CORRIGENDUM - 05 TO NIT NO-84687

Subject: Corrigendum-05 to Tender enquiry for Pre-Bid Tie up with the GIS OEM for Supply & Services of 220 kV GIS for IOCL's Panipat 220kV GIS S/stn Tender / Project.

Ref. No. **Technical Corrigendum-02**

Project: **Pre-Bid Tie up for,
EPCC 03 Package 220KV GIS AND ASSOCIATED WORKS for Maleic Anhydride Project at Panipat Refinery Petrochemical Complex of M/s. Indian Oil Corporation Limited.t**

359755-MDR-000-ELE-21A1-0003

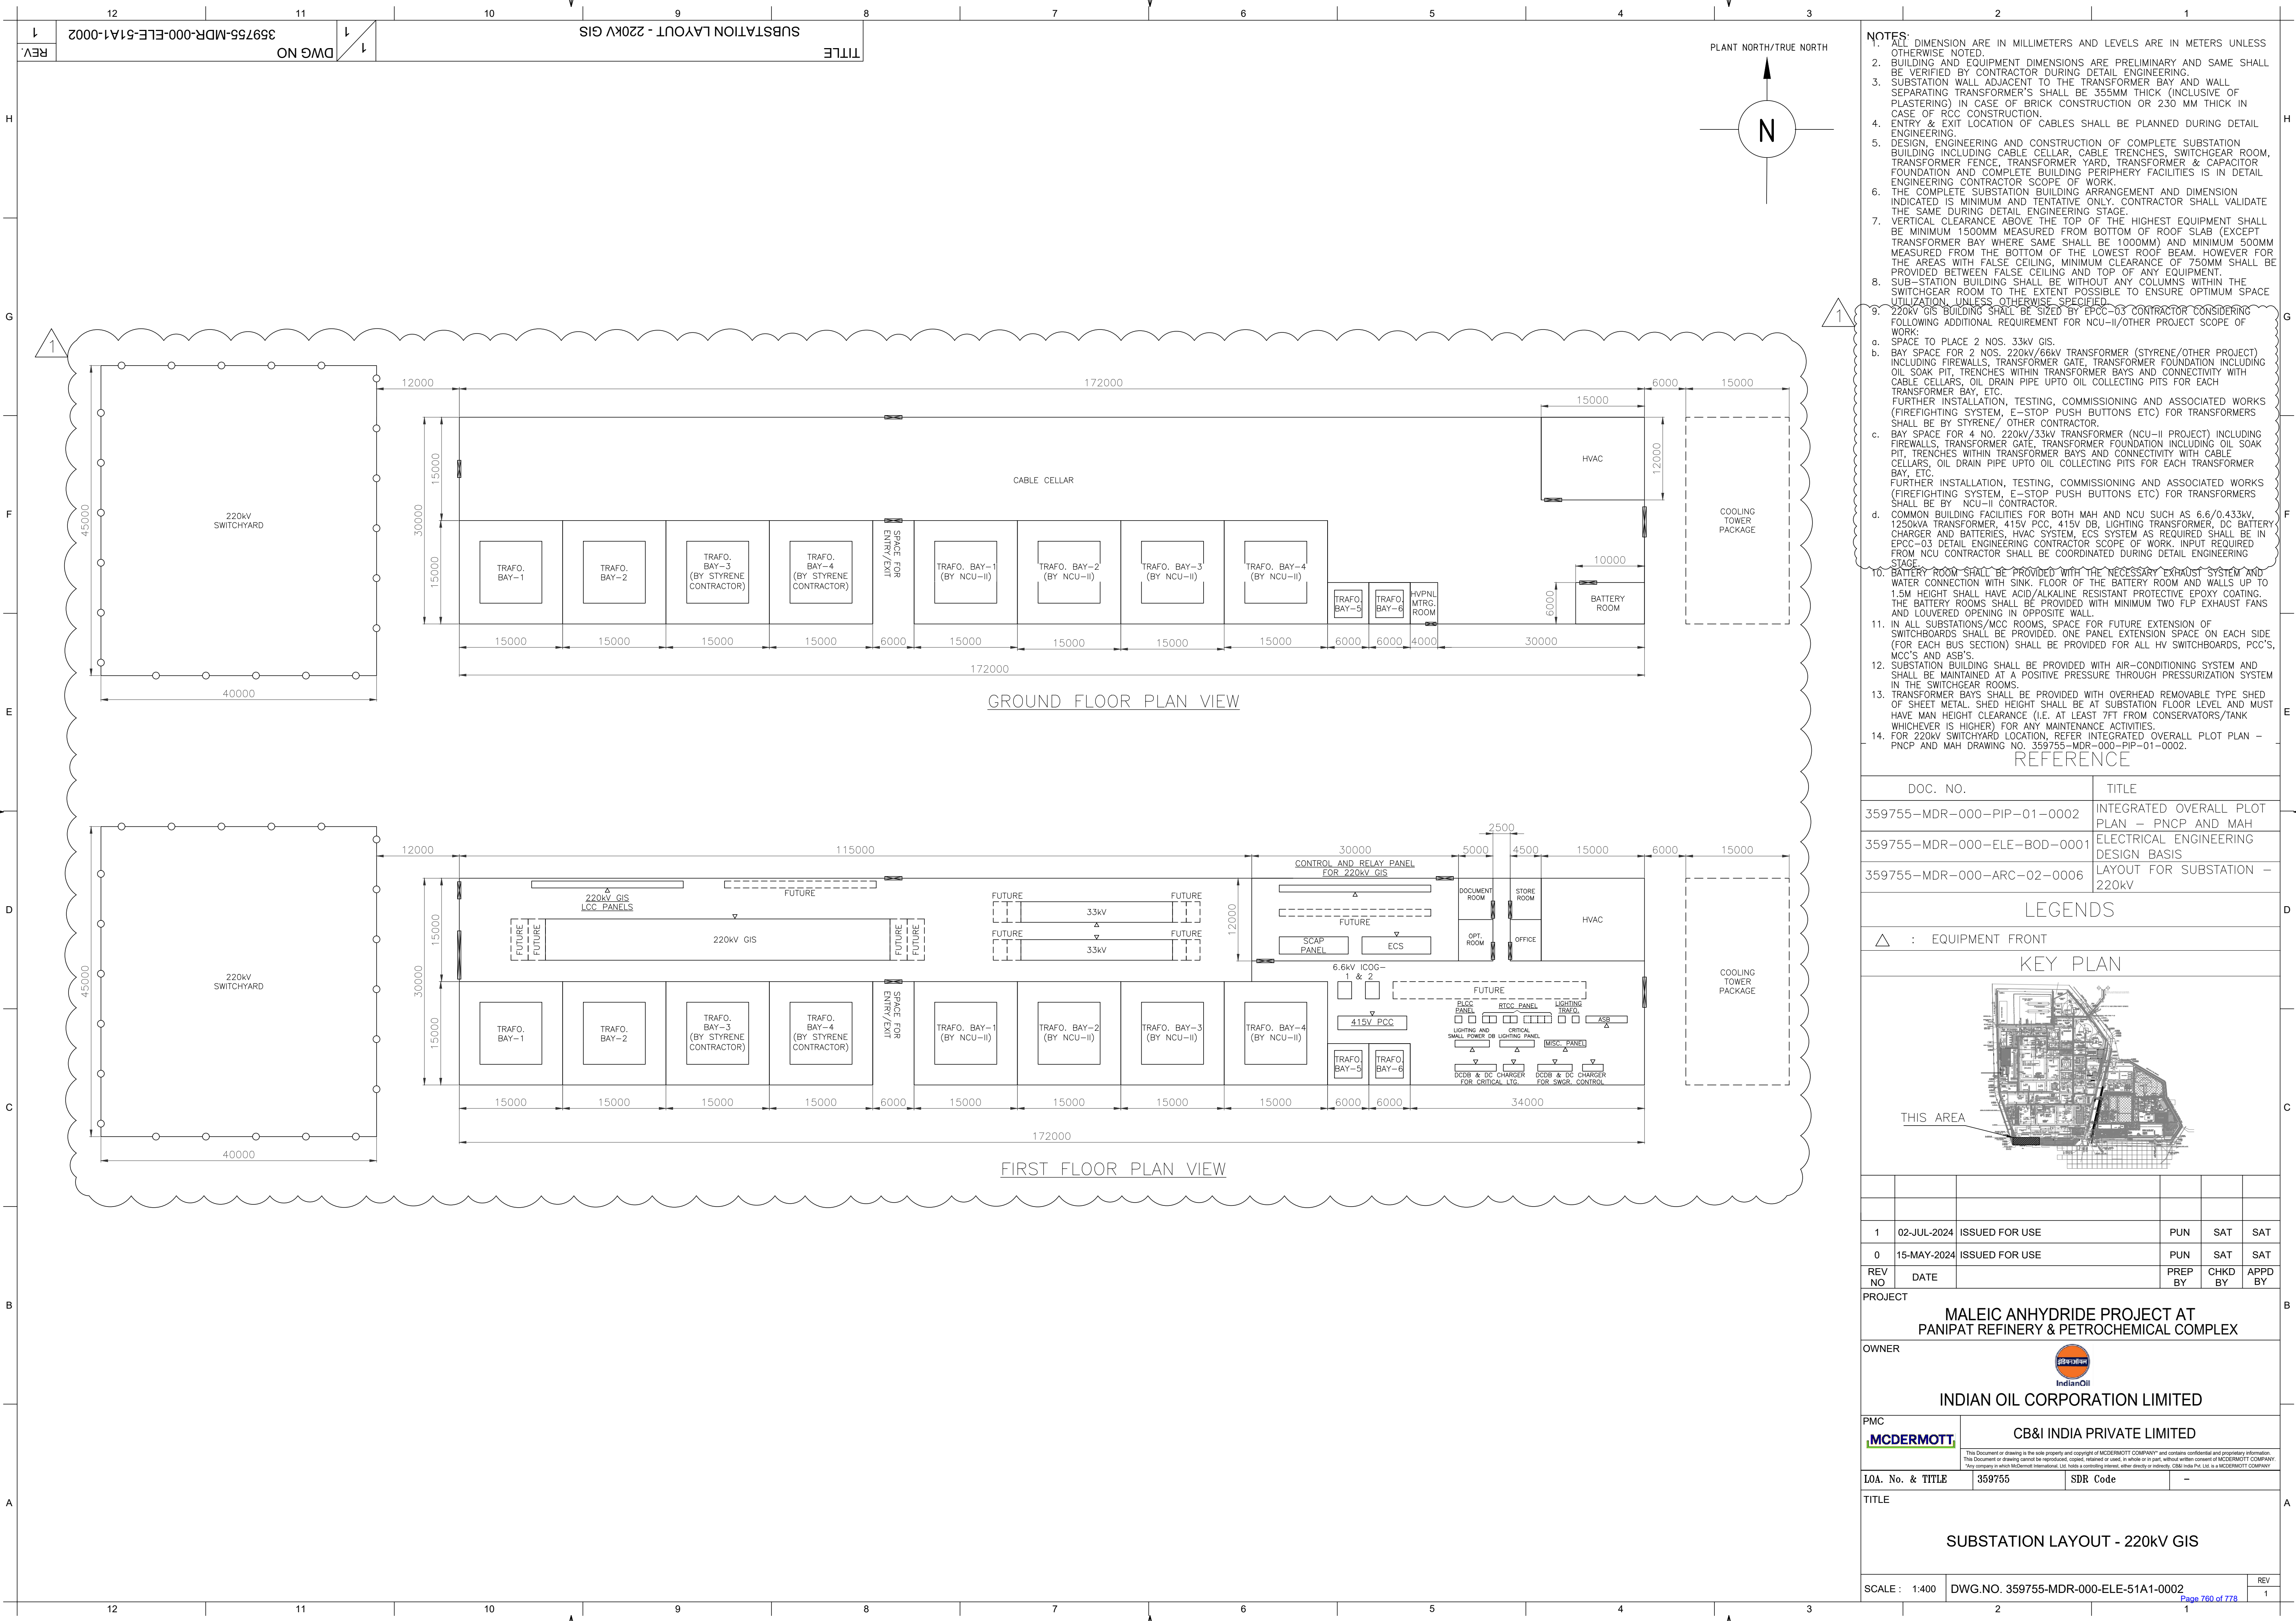
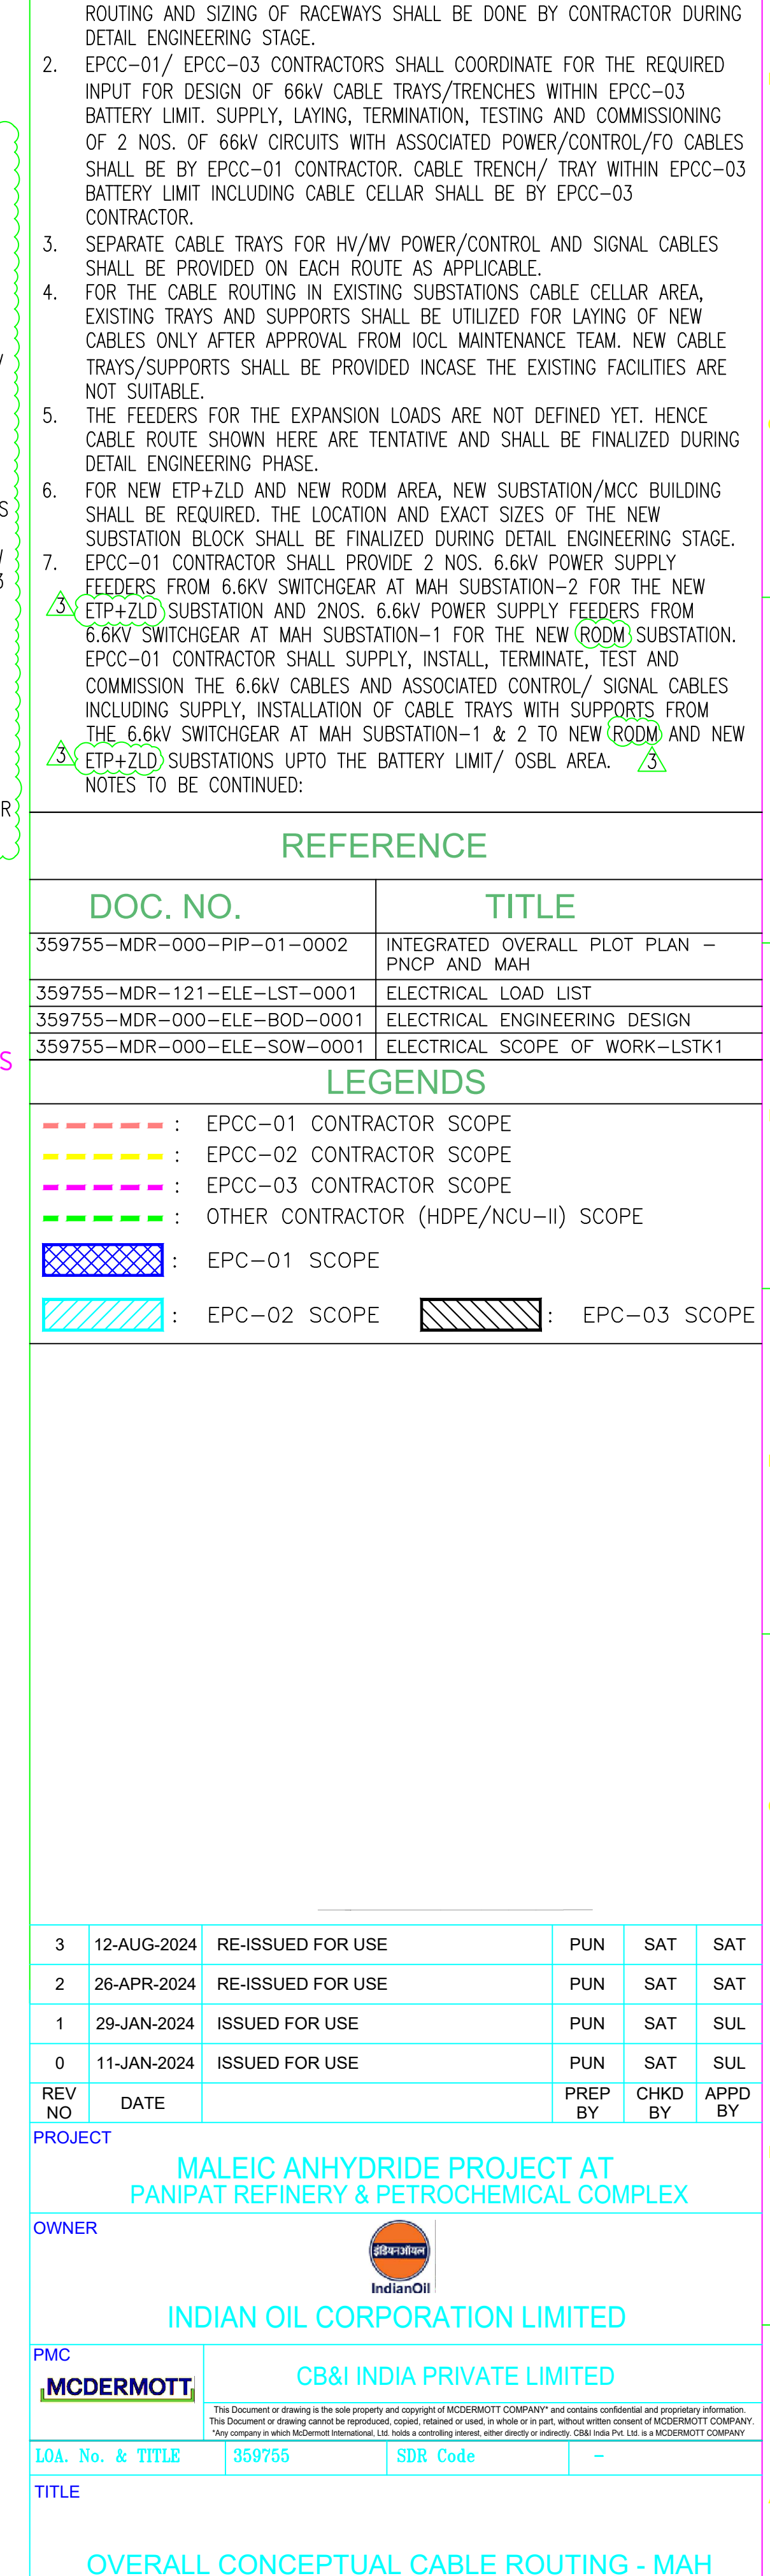
Sl. No.	Part of Bidding Document	Document Reference	Page no	Clause / Item No.	Subject	Existing Clause	Modifications/Additions/Deletions
27.	Volume -2 Section 5.3.3	359755-MDR-000-ELE-21A1-0003	3046 of 5756	-	Overall Key SLD – Integrated MAH & PNCP	-	Modification: Refer to enclosed revised Overall Key SLD – Integrated MAH & PNCP with this amendment.
